RBG-45940

Subject: River Bend Station
Docket No. 50-458
License No. NPF-47
License Amendment Request (LAR) 2001-43, "High Energy Line Break
Analysis Method"

PROPOSED MARKED-UP USAR SECTIONS

FIGURE 6.2-54

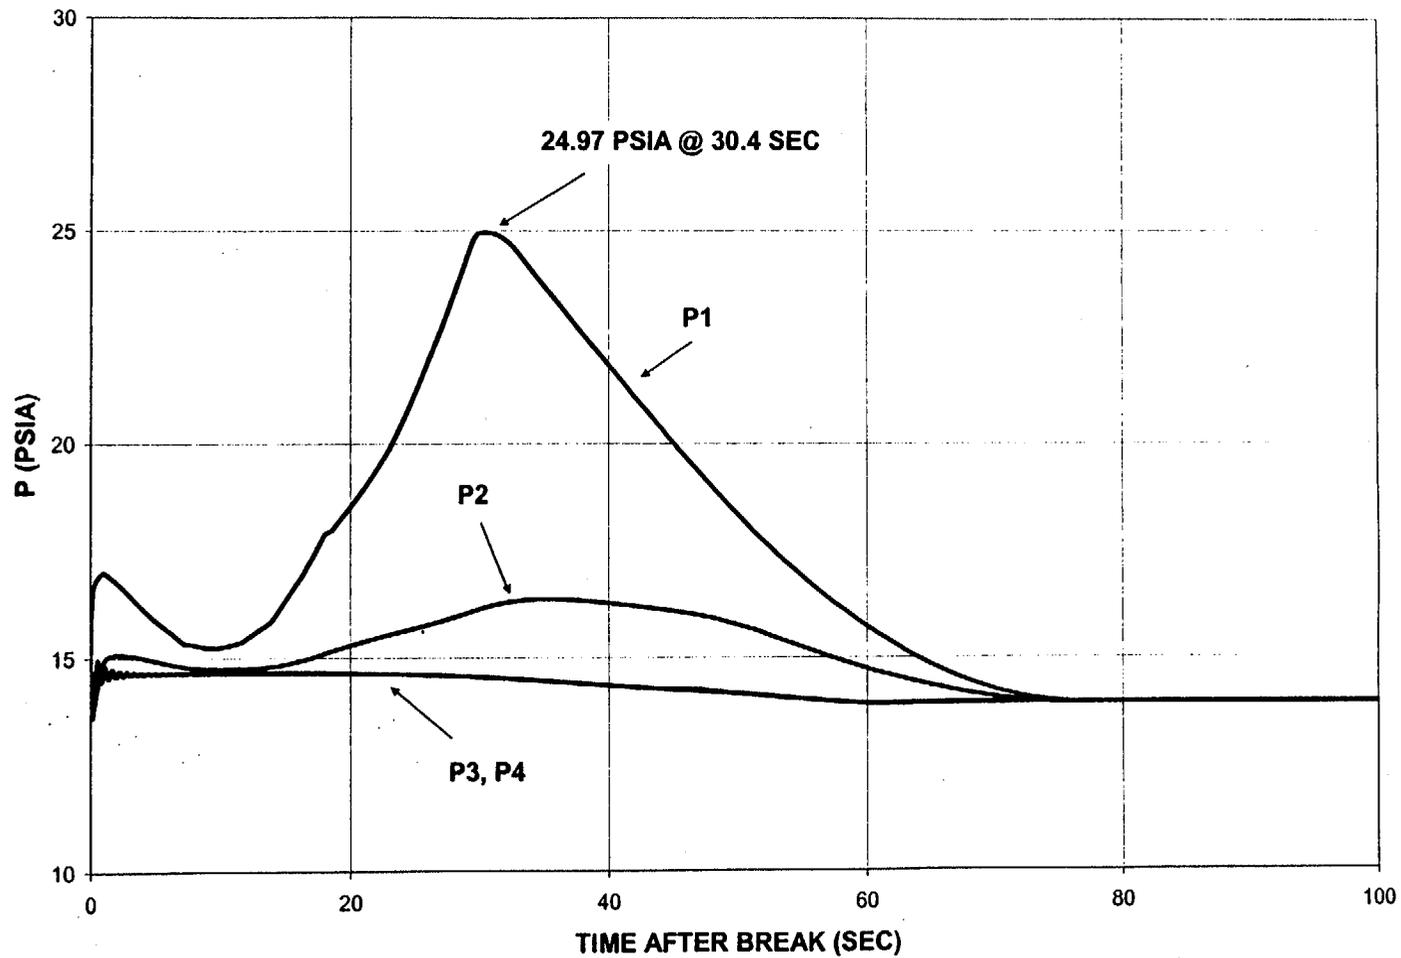
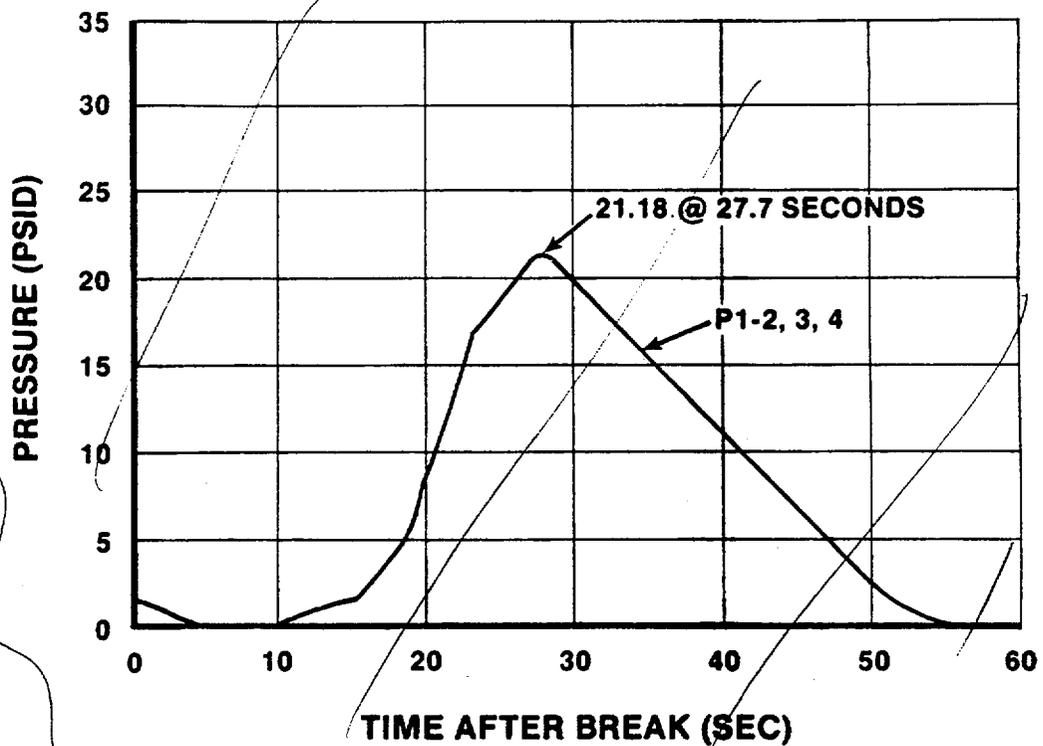
Curves updated in the new figure.

FIGURE 3B-2A

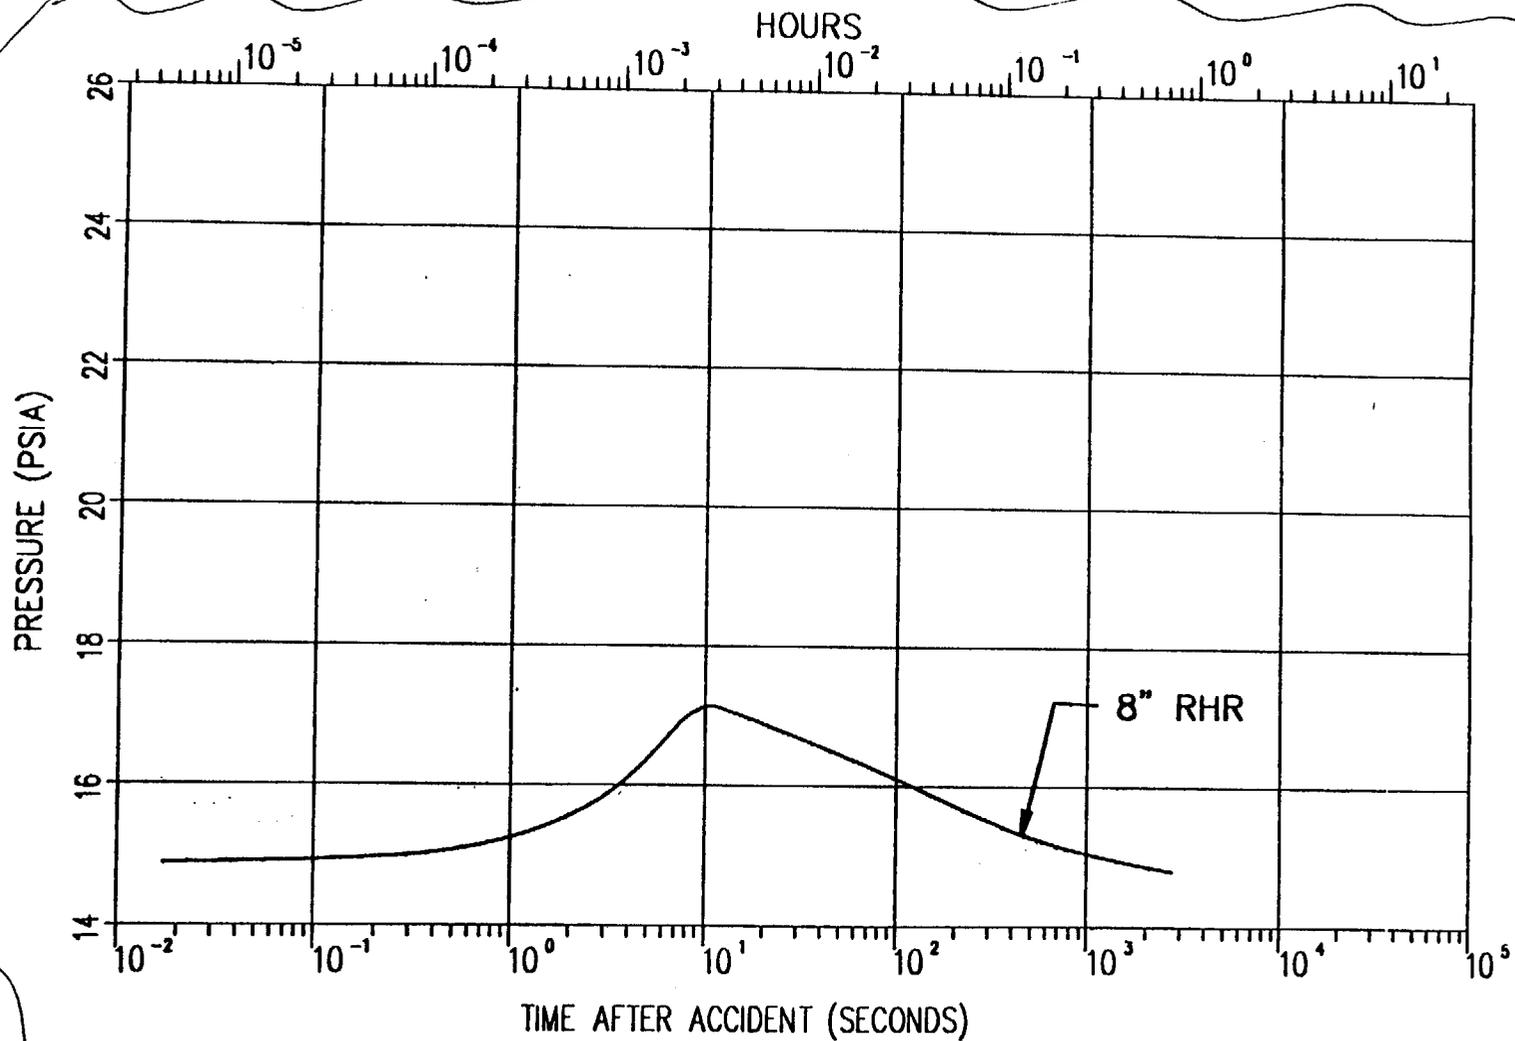
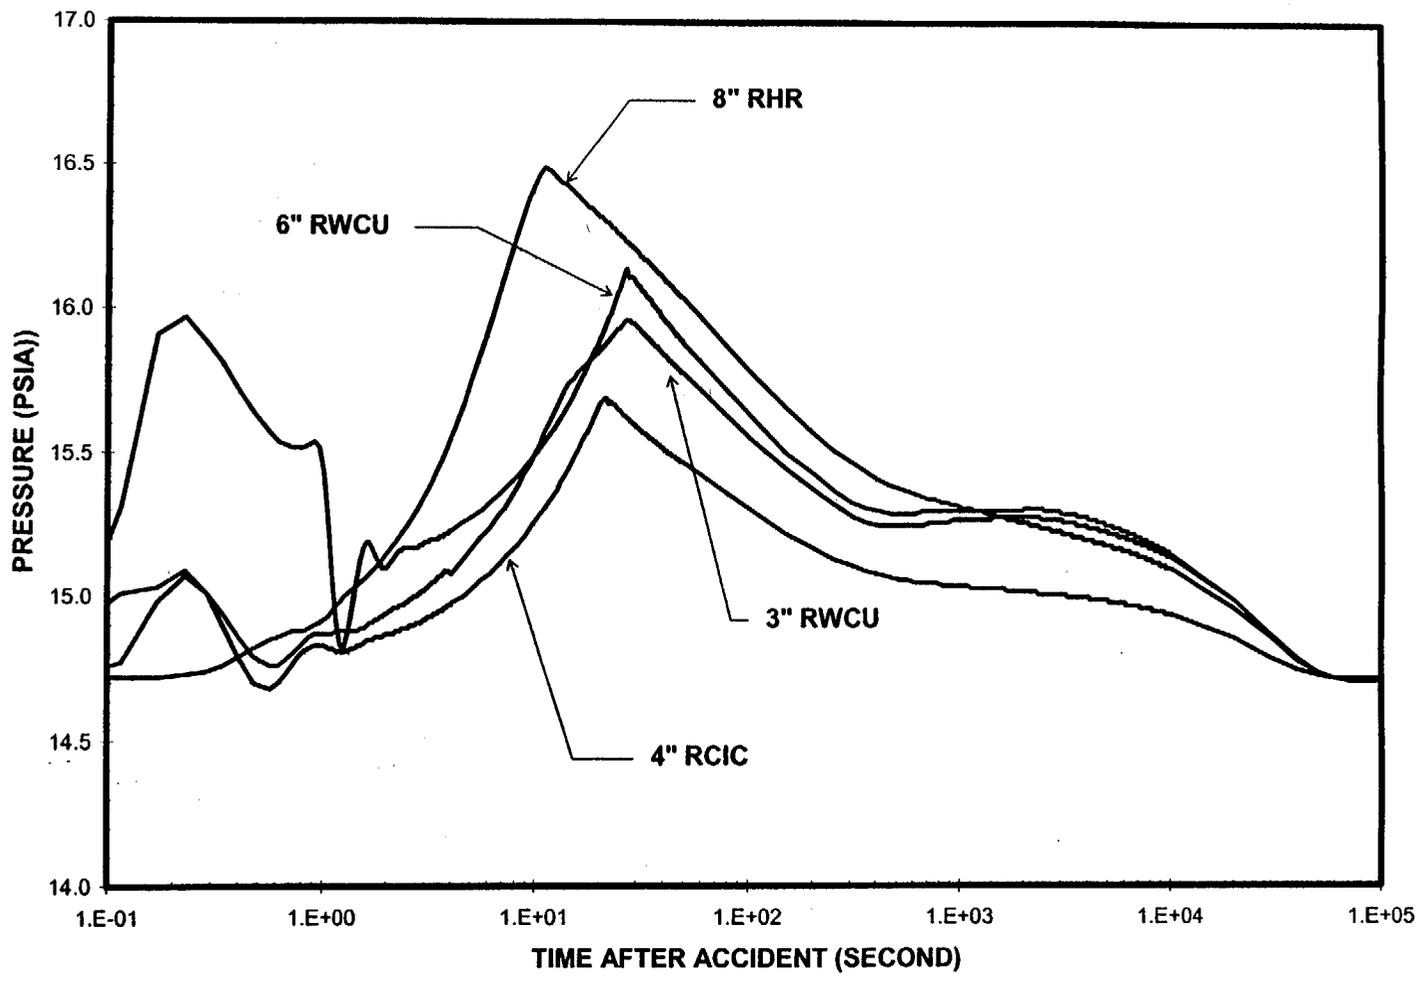
Figures 3B-2 through 3B-21A deleted
 New data presented in Figures 3B-27 through 3B-30

Figures 3B-2 through 3B-21A deleted
 (Figures 3B-3 through 3B-21A are similar to
 Figures 3B-2 and 3B-3)
